CERTIFICATE OF APPROPRIATENESS PLACARD

Alter driveway from concrete to asphalt; remove portion of non-historic brick wall; alter shape of landscape bed

11 S Blount St

COA-0025-2019

Minor Request #2 – Removal of 9 ft portion of the wall marked in red below making the wall end where the parking border begins.

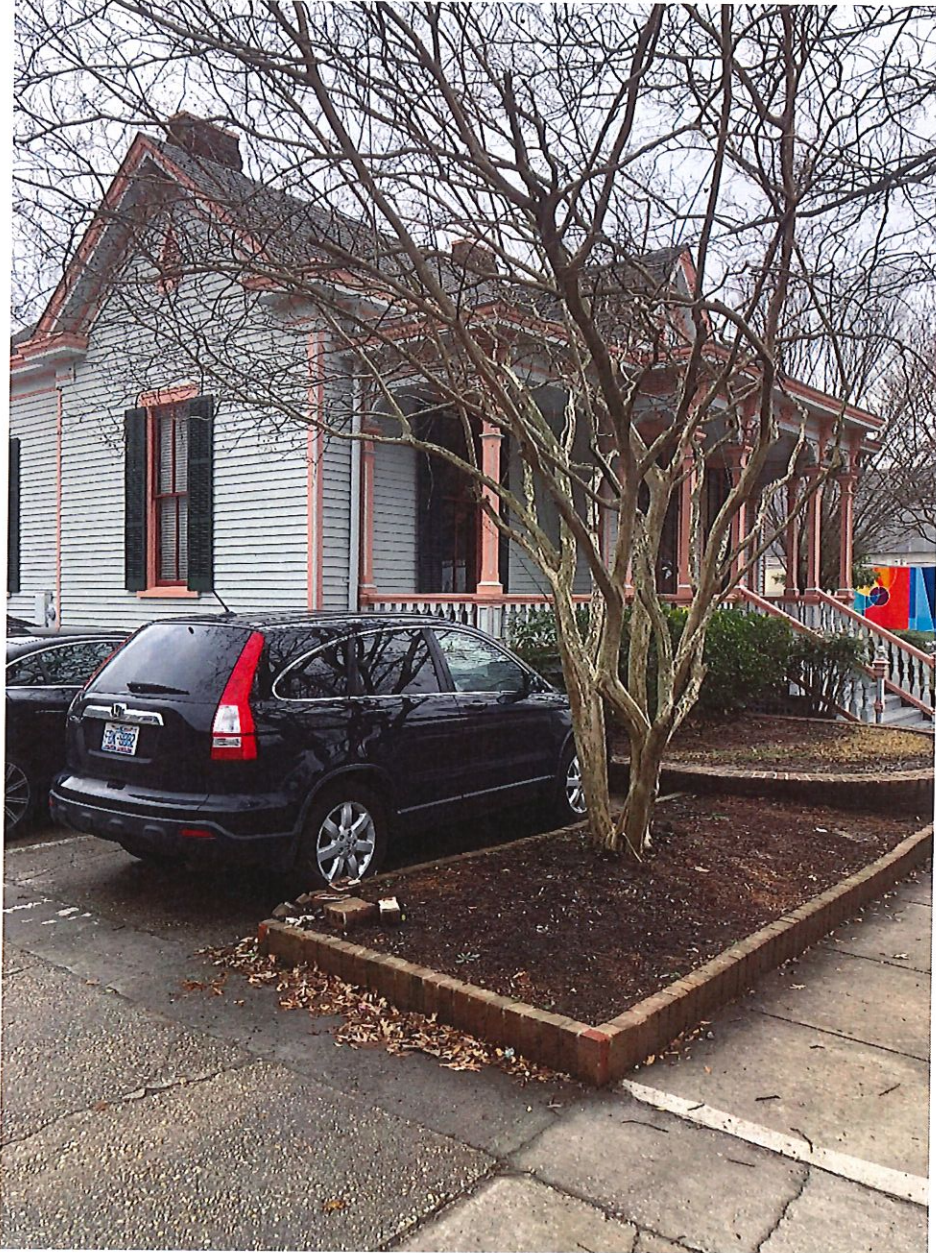
- 1 – Please confirm that the asphalt will be aggregate-textured.
- 2 – Will the rear wall have a new finished edge similar to what is there now?
- 3 – Will the new curved edge of the landscape bed be edged in brick as it is now?

The answers to all three of the questions is yes. The pacer will be will using aggregate-textured asphalt, and in terms of all the brickwork, it will be matching the current facade and will look identical to the way the capped wall looks now and same for the brickwork around the mulched bed. Simply making the adjustments to allow for more space within the lot.
